RotorSport UK Ltd Service Bulletin (Permit)

Title: Stainless steel after-muffler tube		
SB-114 Iss1	Related documents Modification: MC-336 CCAR No.: None	Compliance Category:
Applicability		OPTIONAL or RECOMMENDED or MANDATORY
Aircraft type & model: Calidus with 914UL only Cavalon with 914UL only	Aircraft serial Nos. affected: RSUK/CALS/028 RSUK/CALS/029 RSUK/CVLN/018 Also see note below	
The maintenance manual to be referenced is this stated or subsequent issue.		Calidus RSUK0060 Iss6 Cavalon RSUK0288 Iss5
This form is the response from RotorSport UK Ltd either against a problem found in the product in service requiring a containment or rectification action, or as service information for aircraft modification incorporation. For help, contact RotorSport on 44(0)1588 505060, or email compliance@rotorsport.org . The technical content of this document is approved under the authority of the UK CAA Design Organisation Approval Ref: DAI/9917/06

AG-SB-2016-04-C-EN – Replacement Muffler Tube Cavalon and Calidus

Fig.5: Riveting of steel tube

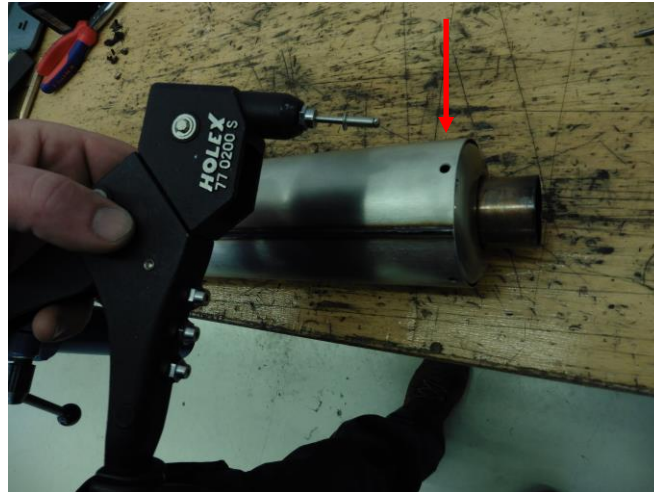
- Replacement of the aluminium muffler tube with the stainless and heat-resistant steel muffler tube.

Fig.8: Installation of locking wire

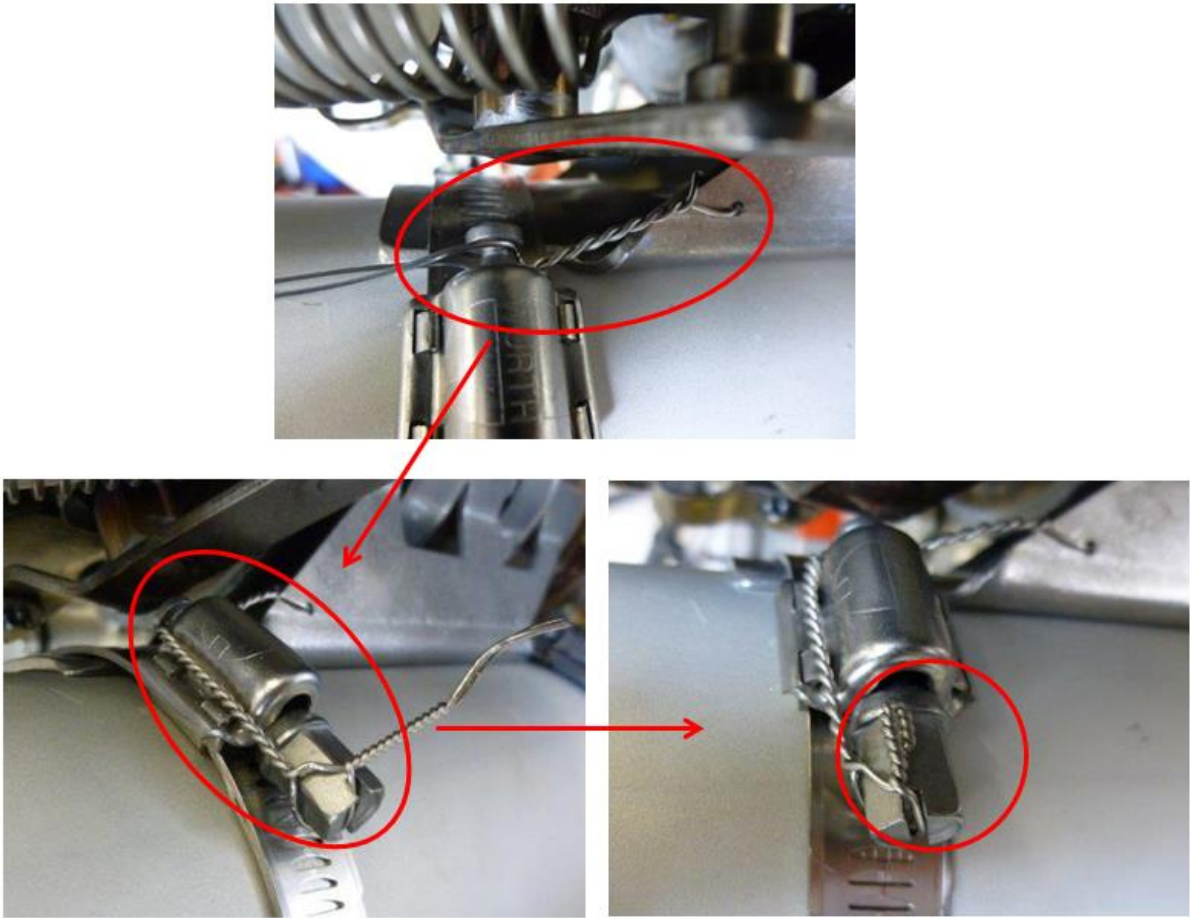
- 15 Fix the bottom cowling according to chapter 52-00-00 4-1. Make sure that the pipe of muffler tube is placed in the middle opening (surrounding 15 mm). If necessary, adjust the position of the muffler tube (Fig.7).
- 16 Remove the bottom cowling and tighten the two hose clamps and hinge pin clamp.
- 17 Secure the screws of hose clamps with locking wire (Fig.8).
- 18 Install the cowling according to chapter 52-00-00 4-1.
